**REPORT TO THE SUBDIVISION AND
DEVELOPMENT APPEAL BOARD**

DATE: June 09, 2026	APPEAL NO.: SDAB2026-0078 FILE NO.: DP2026-01135
APPEAL BY: Peter Chudoba represented by Christopher Davis	
FROM A DECISION OF THE DEVELOPMENT AUTHORITY where a New: Single Detached Dwelling, Accessory Residential Building (garage) was approved at <u>1619 Summit Street SW.</u>	LAND USE DESIGNATION: R-CG Discretionary
COMMUNITY OF: Scarboro	DATE OF DECISION: April 20, 2026
APPLICANT: SE7EN DEZIGN / Ahmad Talib Represented by Rick Grol	OWNER: Abed Alsalam Merhi Represented by Rick Grol

**SUMMARY OF REASONS IN SUPPORT OF APPEAL
DP2026-01135 (1619 Summit Street SW)**

Development Authority Appeal Response

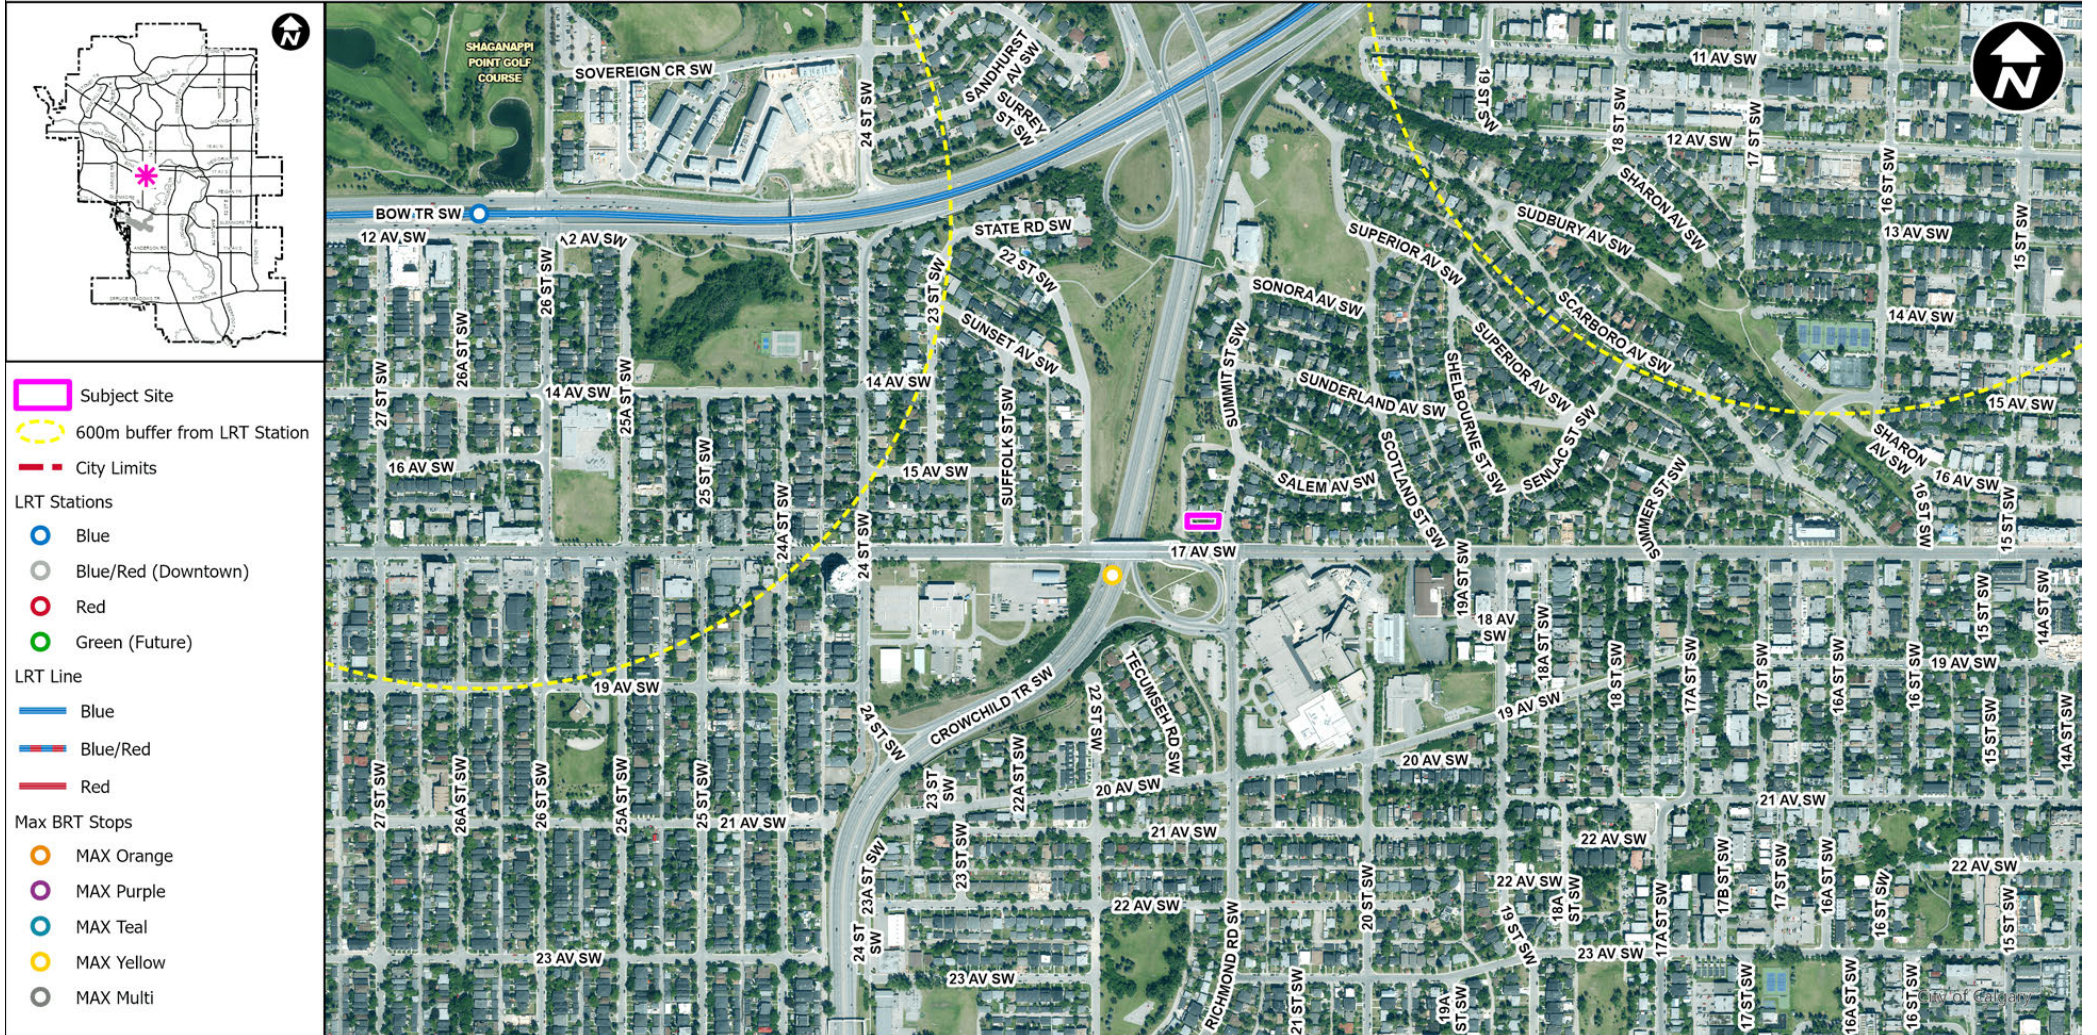
1. Please see the Reasons for Approval.
2. Visual representation of the required relaxation for 541(2) (indicated in red):
